CAUI-4 C2C Transmitter and Receiver Compliance

IEEE 802.3 bm

IEEE Interim - York

Figure 72-12—Transmitter output waveform

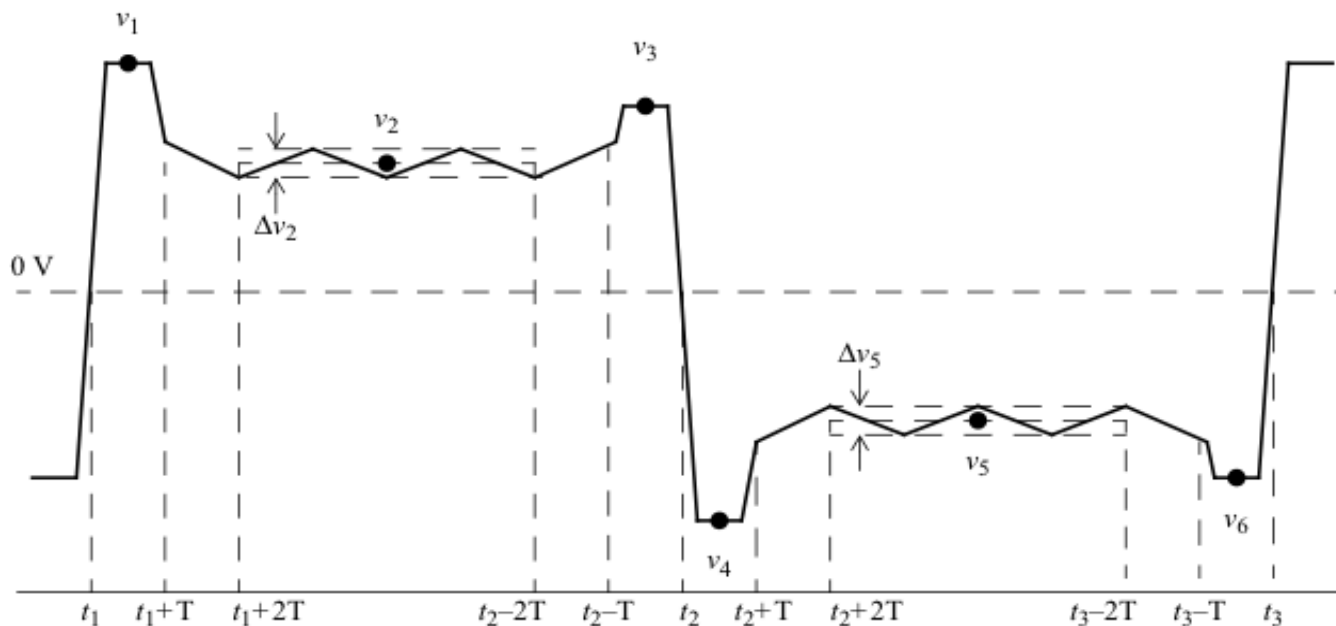
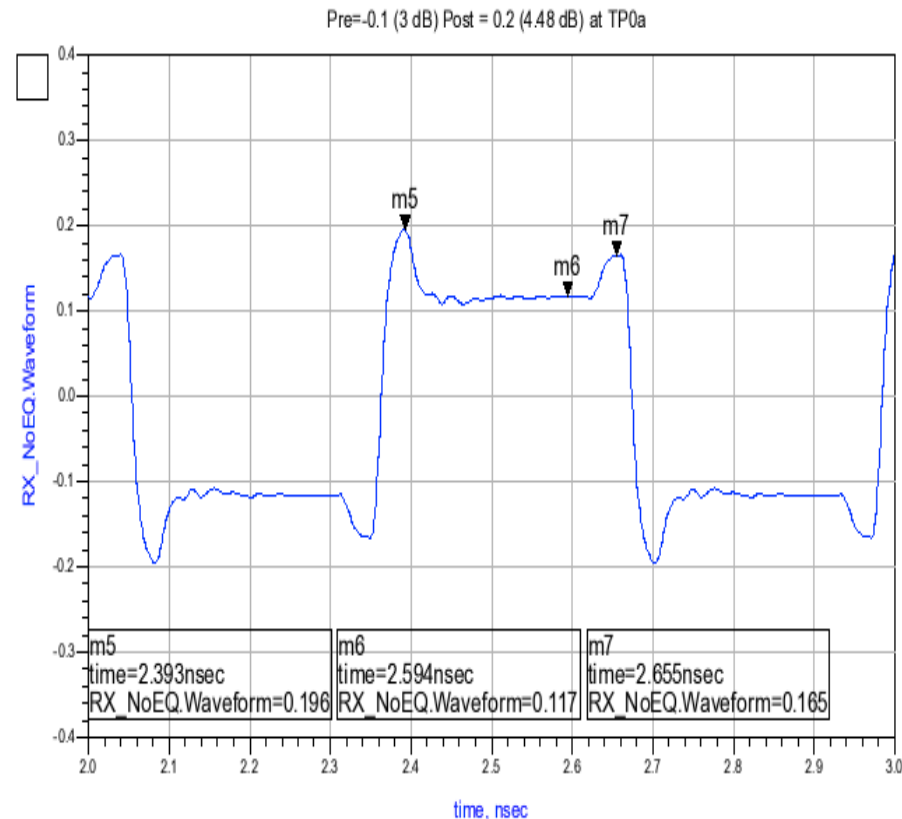
10G-KR Transmitter Compliance (Comment 77, 79, 78, 81, 82, 114,

- A compliance method based on 10G-KR (CL72) but some of constrain eliminated or relaxed is sufficient for CAUI-4 applications
 - $R_{pst} = v_1/v_2 = C(1)$ post cursor = 2.0
 - $R_{pre} = v_3/v_2 = C(-1)$ post cursor = 1.5
 - $VMA = (v_2 - v_5) = 120$ mV at maximum (C1) and C(-1)
 - $\Delta v_2/VMA$, $\Delta v_5/VMA$ is the VMA ripple < 10%
 - $(v_1 + v_4)/v_1$, $(v_2 + v_5)/v_2$, and $(v_3 + v_6)/v_3 < 5\%$

Example Transmitter Waveform (Comment 79)

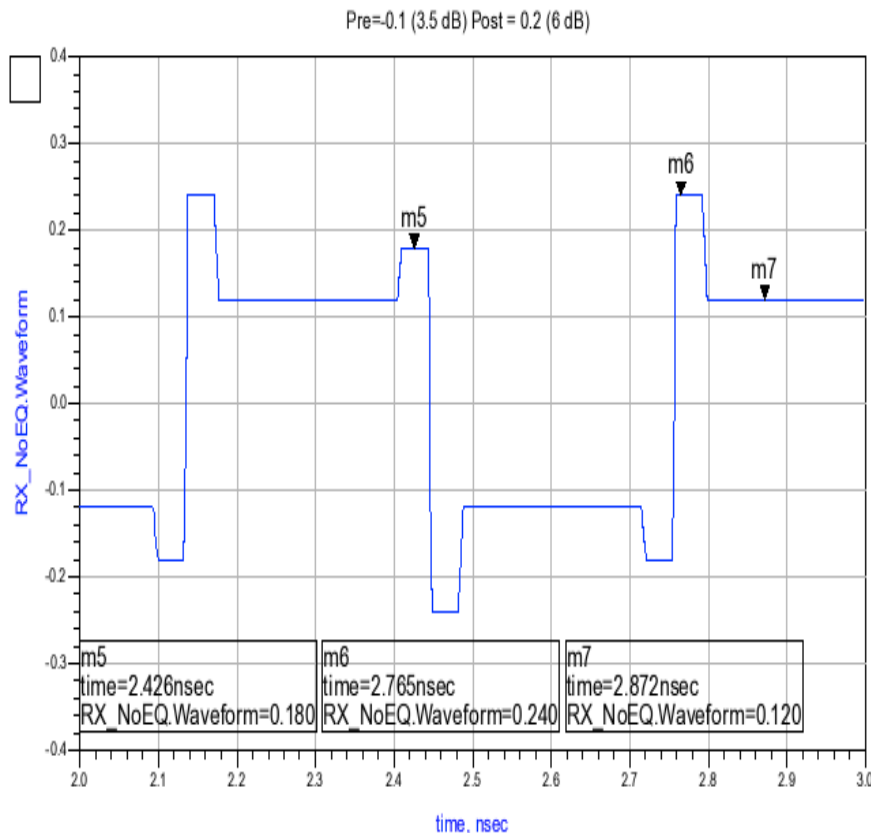
- Example TX output at device output and TP0a
 - KR approach which is consistent with CL83A and accounts for de-emphasis loss due to package/test PCB
 - The de-emphasis need to be guaranteed at TP0a in this example larger pre and post would need to meet $C(1)=2$ and $C(-1)=1.5$

Transmitter Waveform (Comment 79)

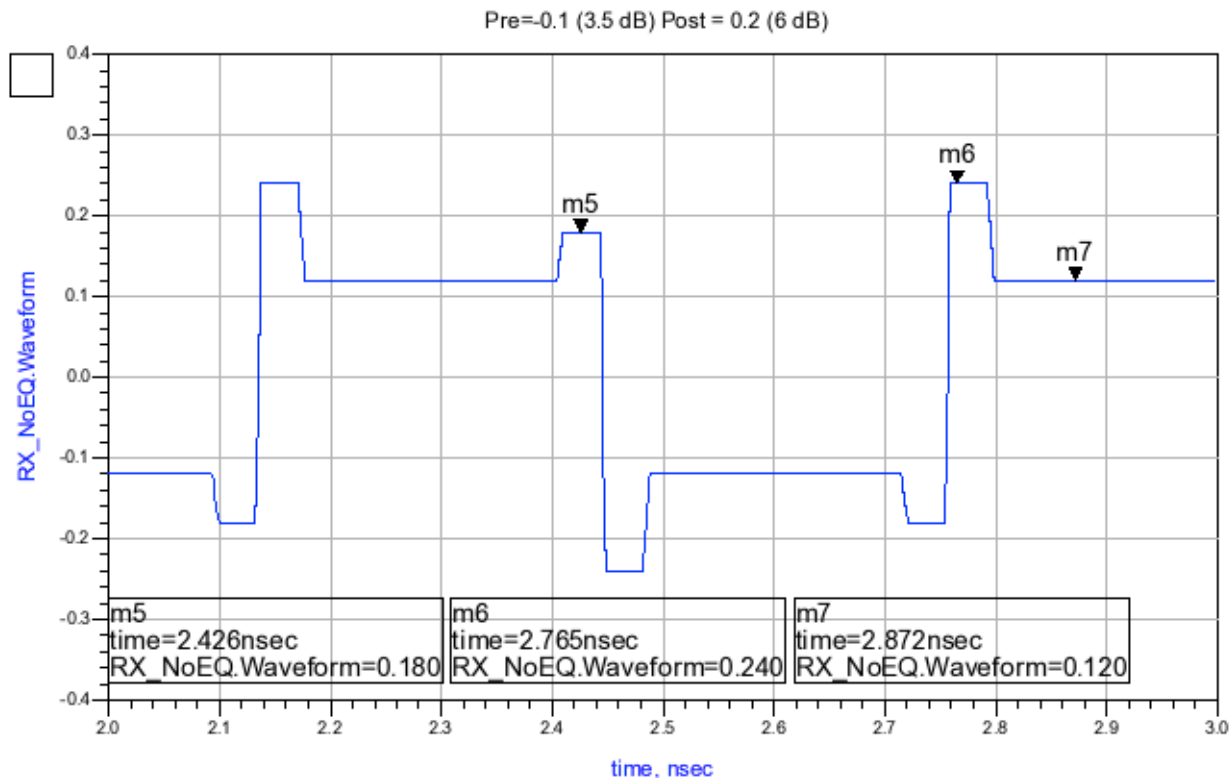
- Per KR CL72 transmitter FFE definition
 - With post cursor $C(1)=2.0$ (6 dB) and pre cursor $C(-1)=1.5$ (3.5 dB)
 - With previous results showing 600 mV fast transmitter and close 15 dB channel the min VMA would then be 120 mV

- Transmitter equalization pre-cursor and post cursor is measured at TP0a. The test pattern for the transmitter output waveform is the square wave test pattern with (8 ones, 8 zeros) of 83.5.10. The scope is set to waveform lock and waveform averaging is set to 32. The waveform is observed through a fourth-order Bessel-Thomson response with a bandwidth of 40 GHz.
- Post cursor is defined as ratio of
- $C(-1)=v1/v2$
- Post cursor is defined as ratio of
- $C(1)=v3/v2$
- The post cursor $C(1)$ measured at TP0a shall be adjustable from 1 to 2.0 in 0.25 steps with variation of +/-0.125
- The pre cursor $C(-1)$ measured at TP0a shall be adjustable from 1 to 1.5 in 0.25 steps with variation of +/-0.125

Expanded CTLE Filters (comment 85, 87)

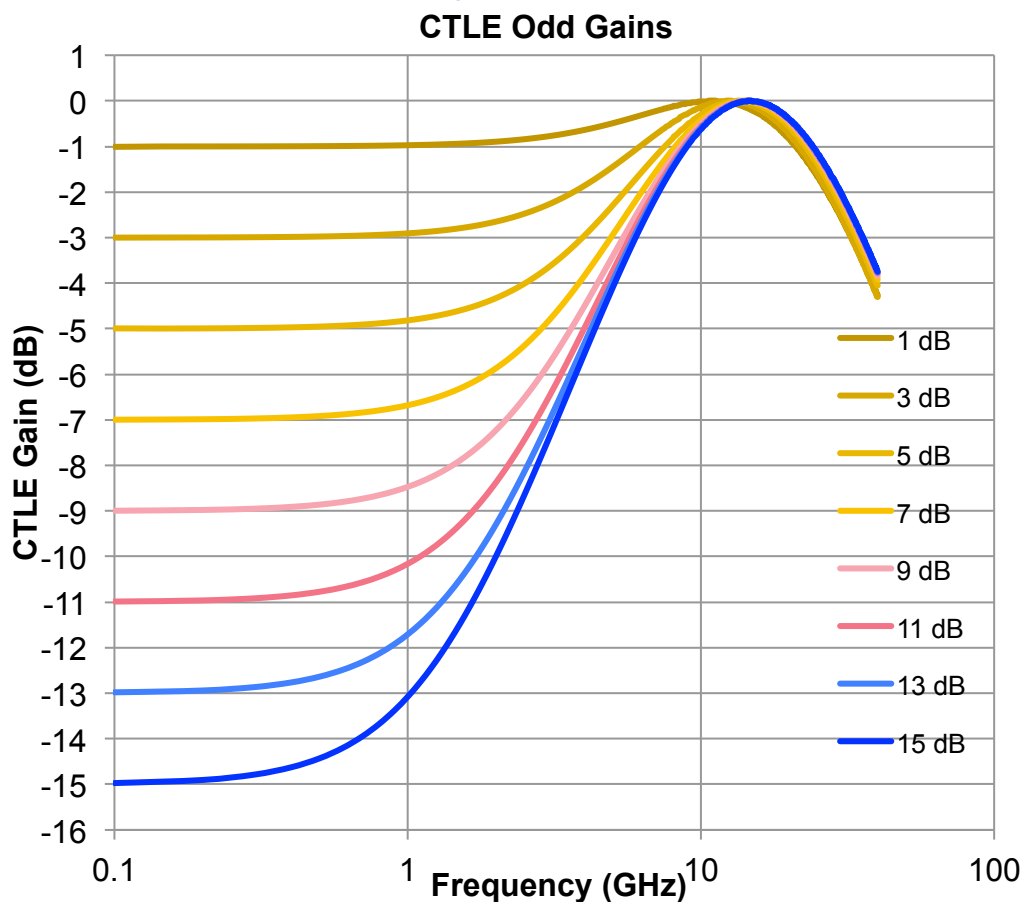
- OIF 28G-VSR and CAUI-4 chip to module were expanded from 9 dB to 15 dB
 - To make sure filter response is always passive G and Z were slightly adjusted and the new coefficient for G and Z have more significant digits
 - With the new filter coefficient the peak gain is in the 0 to -0.005 dB range
